**Board of Zoning Adjustment**  
**Staff Report**  
 October 16, 2017

<b>Case No:</b>	17VARIANCE1059
<b>Project Name:</b>	1133 Everett Avenue Addition
<b>Location:</b>	1133 Everett Avenue
<b>Owner(s):</b>	Matthew Hawkins
<b>Applicant:</b>	Matthew Hawkins
<b>Jurisdiction:</b>	Louisville Metro
<b>Council District:</b>	8 – Brandon Coan
<b>Case Manager:</b>	Dante St. Germain, Planner I

3. Site Plan

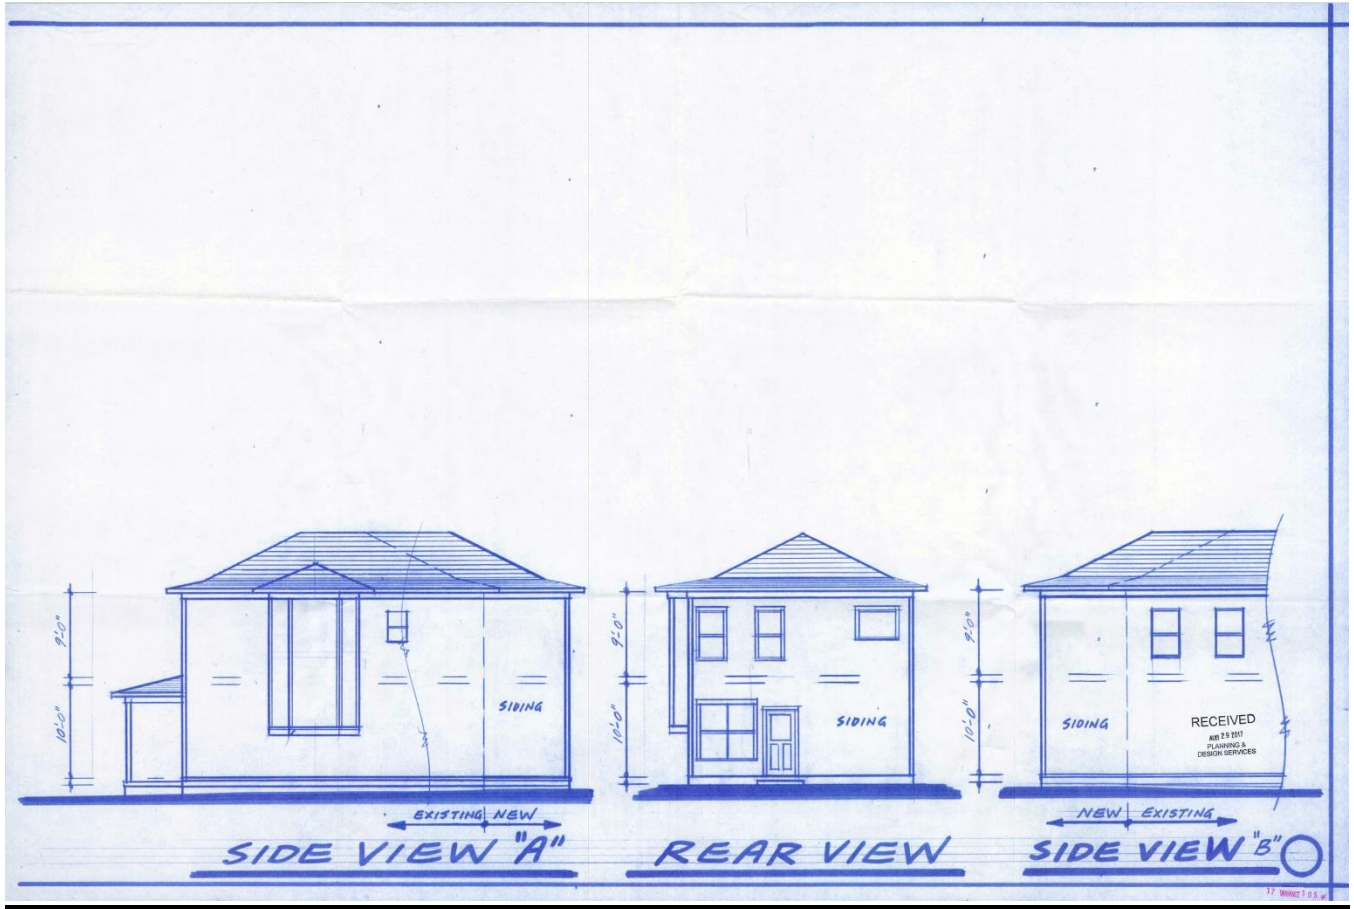
STAFF: The requested variance will not adversely affect the public health, safety or welfare as the encroachment is relatively small and is in line with an existing encroachment by the principal structure, which has caused no known adverse effects.

STAFF: The requested variance will not allow an unreasonable circumvention of the zoning regulations as the addition is proposed to be located on the same footprint as the prior addition, in line with the existing principal structure.

STAFF: The requested variance arises from special circumstances which do not generally apply to land in the general vicinity or the same zone as the principal structure already encroaches into the side yard, and the addition is proposed to be in line with this structure.

Staff finds that the requested variance is adequately justified and meets the standard of review.
